Subject: **Preliminary Comments Regarding Salinas Valley Basin Groundwater Sustainability Agency Draft Groundwater Sustainability Plan Chapters 1 through 3 (EKI B60094.03)**

Subject: **Preliminary Comments Regarding Salinas Valley Basin Groundwater Sustainability Agency Draft Groundwater Sustainability Plan Chapter 4 (EKI B60094.03)**

Subject: **Preliminary Comments Regarding Salinas Valley Basin Groundwater Sustainability Agency Draft Groundwater Sustainability Plan Chapter 5 (EKI B60094.03)**

Appendix B
Focused Technical Review of Public Draft GSP

Figure 21 - Average Groundwater Level Changes in the Deep Aquifers (1986-2016)

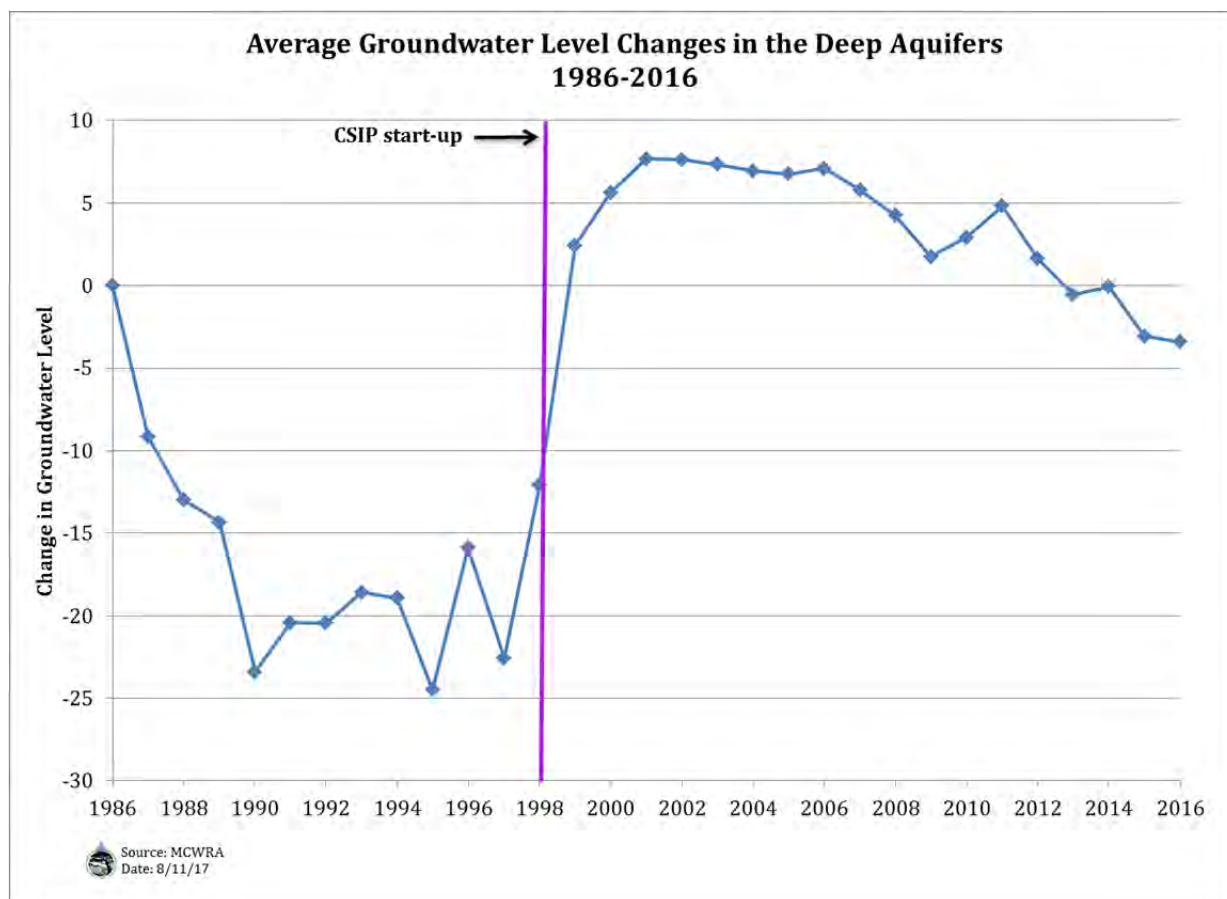
Figure 21 shows that average groundwater levels in the Deep Aquifer gradually decreased between 1986 and 1997, rebounded after CSIP start-up in 1998, and have gradually decreased again over the past two decades. Hydrographs from the United States Geologic Survey ("USGS") Deep Aquifer nested Monitoring well (14501E24L02,03,04,05) in Marina⁴, located along the coast of the Monterey Subbasin (Attachment B), also show that water level declines in the Deep Aquifer (Attachment B), particularly since 2015. This decline is consistent with increased production from the Deep Zone in the 180/400 foot Aquifer Subbasin. Deep Zone production rates are presented on Figure 23 of the 2017 MCWRA Report (Attachment A). Based upon this information, SMC should be established for the Deep Aquifer to stop further water level declines. Water levels in this aquifer are below sea level and declining; therefore, the potential for salt-water intrusion into this aquifer is increasing. Given that the Deep Aquifer provides the only source of potable water in salt-water intruded areas other than the Castroville Seawater Intrusion Project (CSIP), projects should be prioritized to provide alternative water supplies to these areas or management actions should be implemented to reduce withdrawals from the Deep Aquifer.

Chart 1 – Hydrograph of Deep Aquifer Well

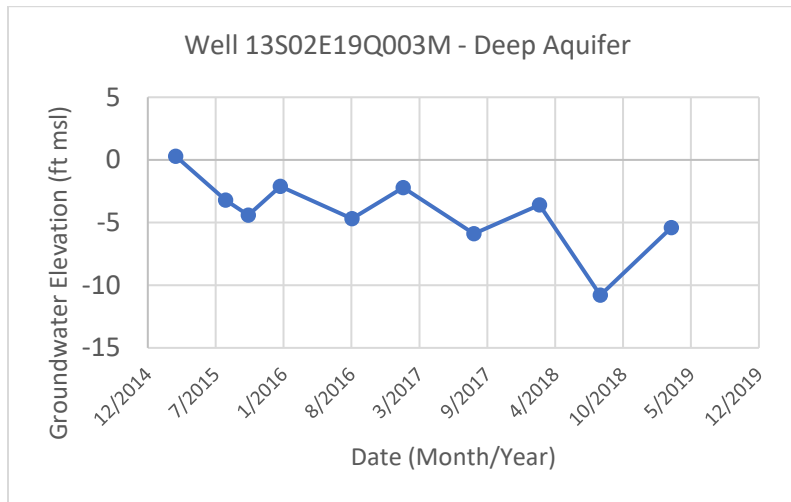
Groundwater Sustainability Agency (SVGSA) should work to fill this data gap and at a minimum, should include the limited available data in the draft GSP.

Chart 2a – SMCs for 180-Foot Aquifer Water Level RMWs Near Coast

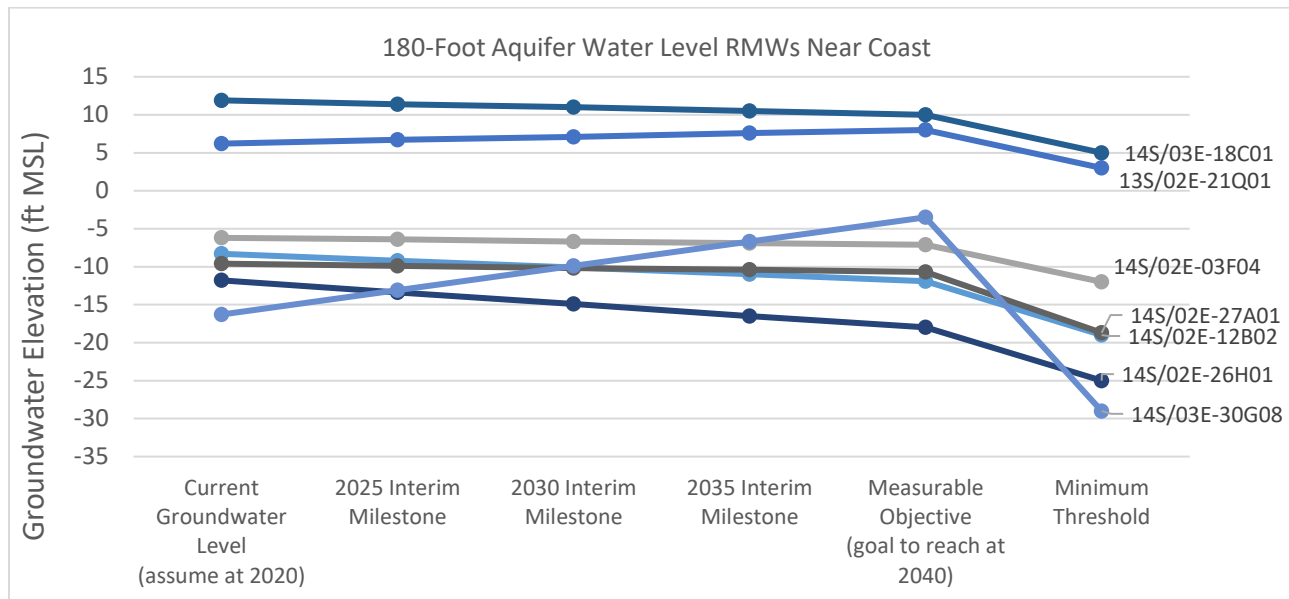
- Charts 2a and 2b** below reflect the proposed SMCs (per Table 8-3 of the draft GSP) for the 180-Foot and 400-Foot Aquifer water level representative monitoring wells (RMWs) located in and near the areas of seawater intrusion (wells identified on excerpted Figures 8-2 and 8-3 above). If the measurable objectives (MOs) are met, this represents a relatively small decline in water levels from current conditions in most wells, and in some wells an increase in water levels. However, the MTs in most cases represent a substantial decline in water levels from current conditions, to levels well below sea level. **Given that current conditions are resulting in significant seawater intrusion conditions, it is unclear from the draft GSP how such declines in water levels will result in sustainability for the beneficial uses and users of the subbasin, and how seawater intrusion will be limited to 2017 limits (i.e., the seawater intrusion MTs).**

**Figure 1 - Seawater Intrusion SMCs Relative to Domestic Wells,
Public Supply Wells, DACs, and Community Water Systems
Salinas Valley Basin GSA**

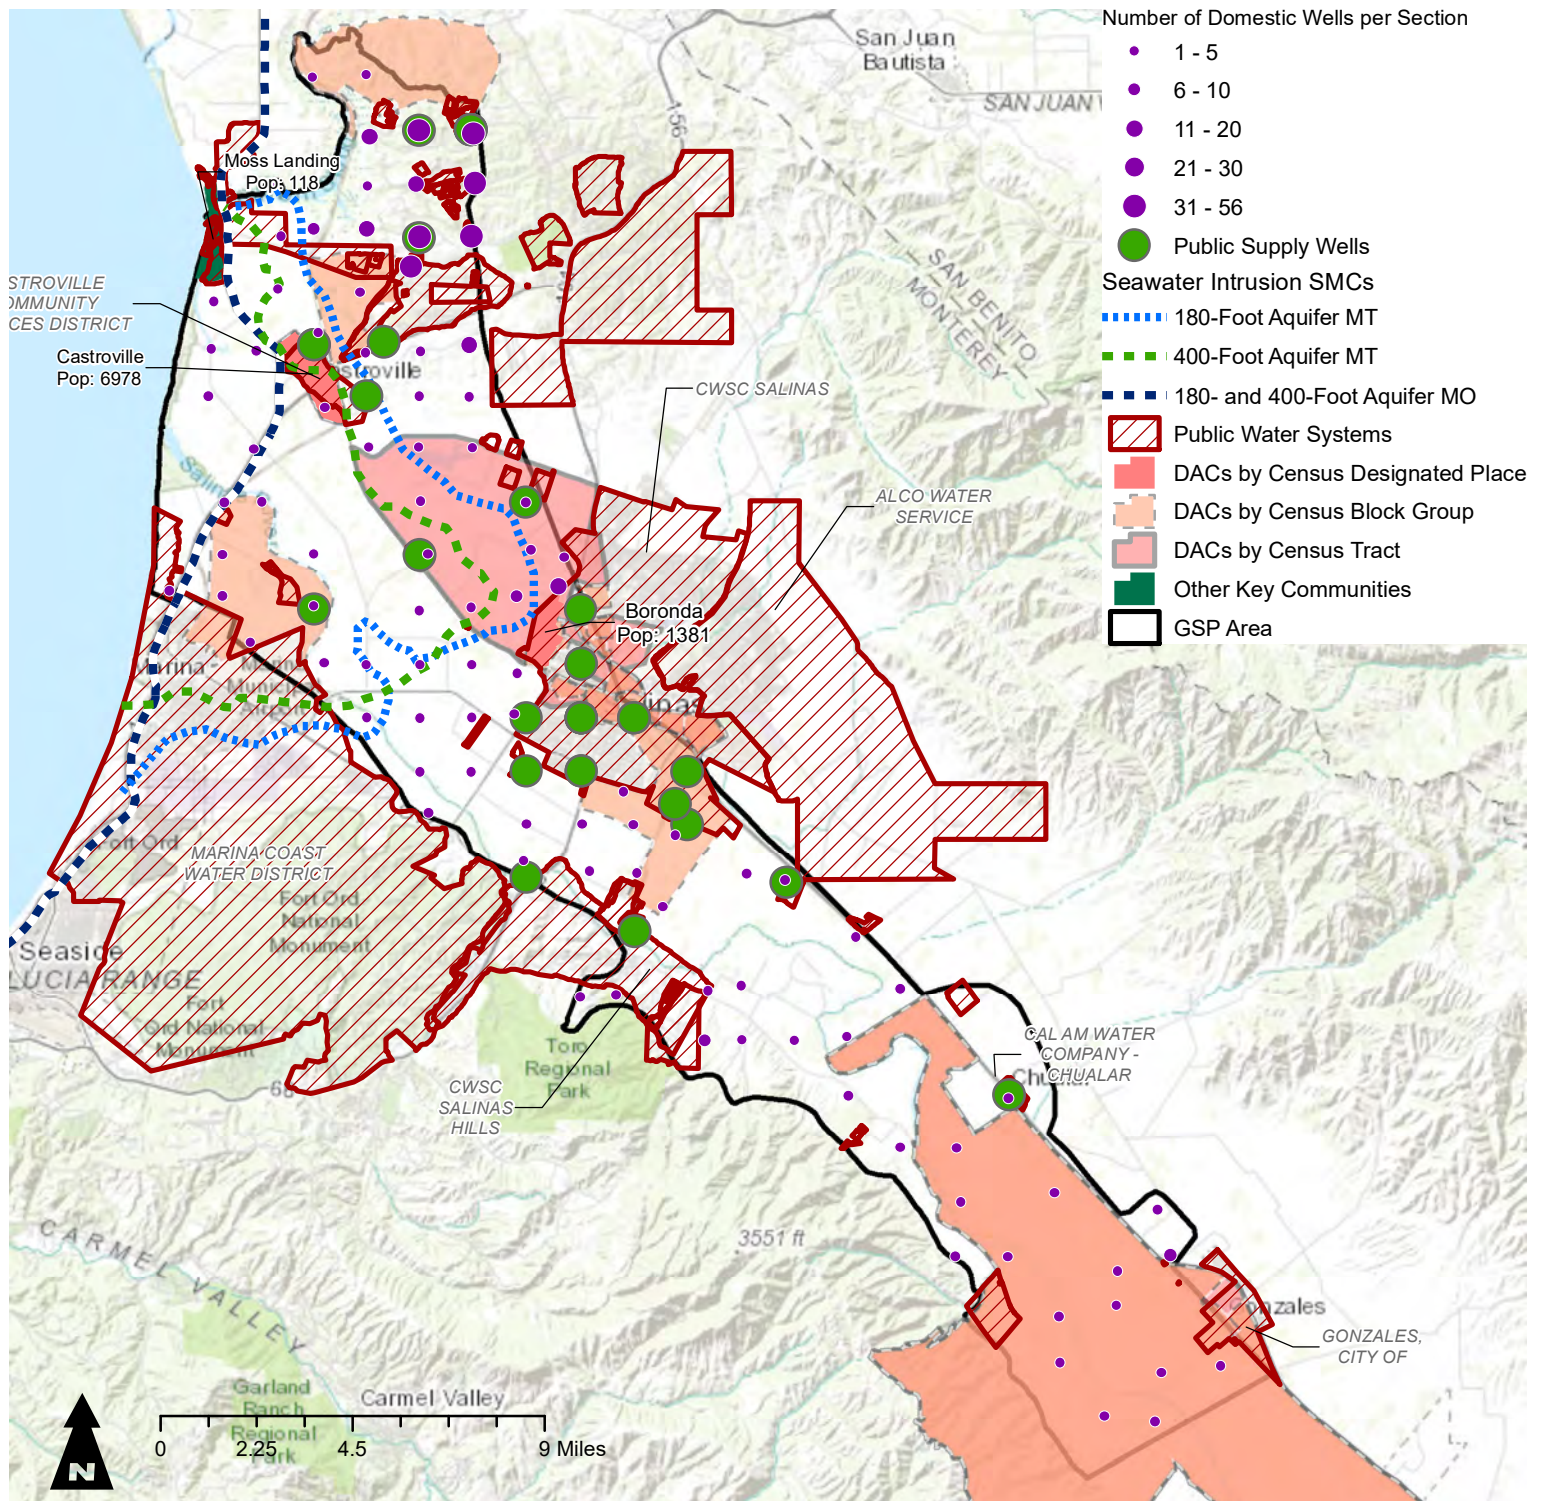
As shown on **Figure 1**, a significant proportion of the 180/400-Foot Aquifer Subbasin (subbasin) is designated as Disadvantaged Communities (DACs), totaling a population of roughly 50,000 people based on DWR-provided Census data.¹ Members of these DACs and other communities receive their drinking water from roughly 500 domestic wells located within the subbasin and a variety of public water systems, including approximately 30 separate community water systems.

Figure 1 also shows the proposed Minimum Threshold (MT) contours for seawater intrusion for the 180-Foot and 400-Foot aquifers. According to Section 8.8.2 of the draft GSP, these MT contours represent “the 2017 extent of the 500 mg/L [milligrams per liter] chloride concentration isocontour as mapped by MCWRA [Monterey County Water Resources Agency],” and thus represent near-current seawater intrusion conditions. Based on these data, a significant portion of the drinking water supply in the subbasin is at imminent risk of seawater intrusion impacts if seawater intrusion is not halted, including: 1) a high concentration of domestic well users located east of Moss Landing and north of Castroville, 2) domestic well users in and around the DAC of Boranda, 3) public supply wells located near Castroville (a DAC), and 4) public supply wells located near Salinas (which includes DACs). **For the reasons discussed further below, the draft GSP does not lay out a clear and robust plan to achieve sustainability, and protect drinking water for these vulnerable beneficial uses and users.**

**Figure 2 - Representative Monitoring Network for GW Levels Relative to Domestic Wells, Public Supply Wells, DACs, and Community Water Systems
Salinas Valley Basin GSA**

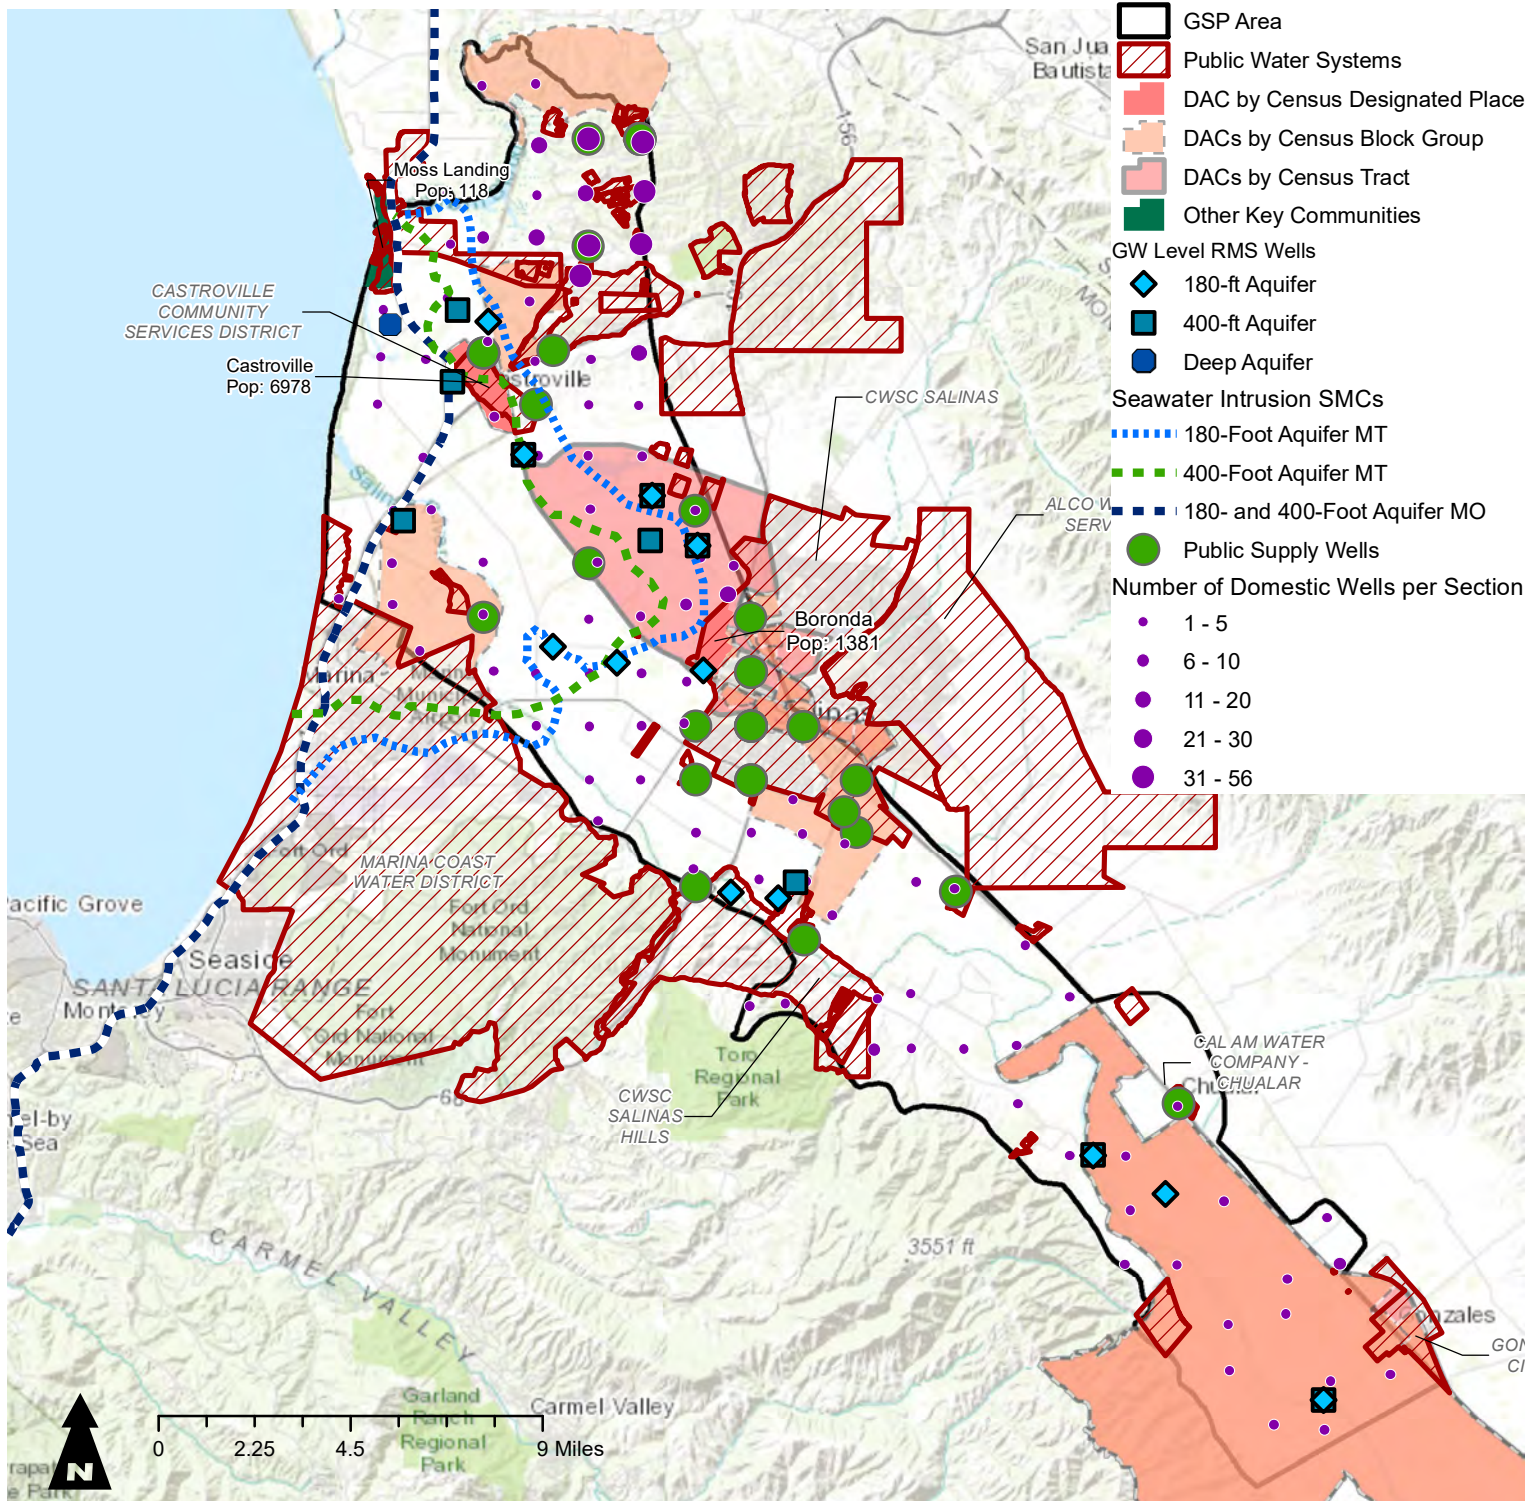
- **Figure 2** shows the RMWs for water levels as well as the locations of domestic wells, public supply wells, DACs and public water systems in the subbasin, and the seawater intrusion MO and MTs. There are no water level RMWs located in the northernmost portion of the subbasin, in an area with a high concentration of domestic well users. **Thus, the water level monitoring network is inadequate to properly monitor for these sensitive beneficial users, as required under 23 CCR §354.34 (b)(2).**
